UNITED STATES PATENT AND TRADEMARK OFFICE

APPLICATION NO.	FILING DATE	FIRST NAMED INVENTOR	ATTORNEY DOCKET NO.	CONFIRMATION NO.
10/712,052	11/14/2003	Yong-Joon Cho	SEC.1063	9035
20987 7590 03/21/2007 VOLENTINE FRANCOS, & WHITT PLLC				INER
ONE FREEDO	M SQUARE		UMEZ ERONINI, LYNETTE T	
11951 FREEDOM DRIVE SUITE 1260 RESTON, VA 20190		50	ART UNIT	PAPER NUMBER
			1765	
SHORTENED STATUTOR	Y PERIOD OF RESPONSE	MAIL DATE	DELIVERY MODE	
3 MO	NTHS	03/21/2007	PAPER

DETAILED ACTION

FIG. 2

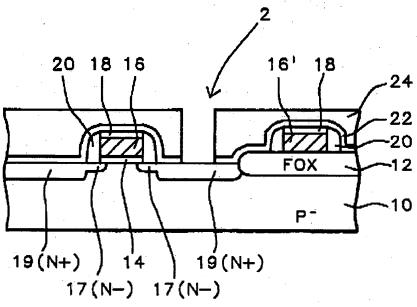
As to claims 1, 2, 5, 10, 12, 14, and 15, Tseng discloses a method of making DRAM cells by forming node contact openings 2 in the second 24 and first insulating 22 layers in a FET (field effect transistor) on a substrate 10, forming a planar insulating layer over FETs and etching contact openings in each FET (Abstract; column 3, line 52 – column 5, line 40; and FIG. 2). The aforementioned reads on,

Tseng teaches insulating layer **22** (same as Applicant's buffer layer and etch stop layers), composed of a SiO₂ layer and an upper Si₃N₄ layer that is conformally deposited over device areas and field oxide area **12** (column 5, lines 24-27), which reads on.

sequentially forming a buffer layer 22 and an etch stop layer 22 over the source region 17, 19, the drain region 17, 19 and the sidewall spacers 20 of the gate 14 to obtain an intermediate structure (column 5, line 24-28),

dry etching (same as plasma etching) the first insulating layer 24 until the etch stop layer 22 over the source region 17, 19, the drain region 17, 19 and the sidewall spacers 20 is exposed to form self-aligned contact holes 2 in the first interlayer insulating 24 over the source region 17, 19 and the drain region 17, 19 (column 5, lines 37-41), in claim 1.
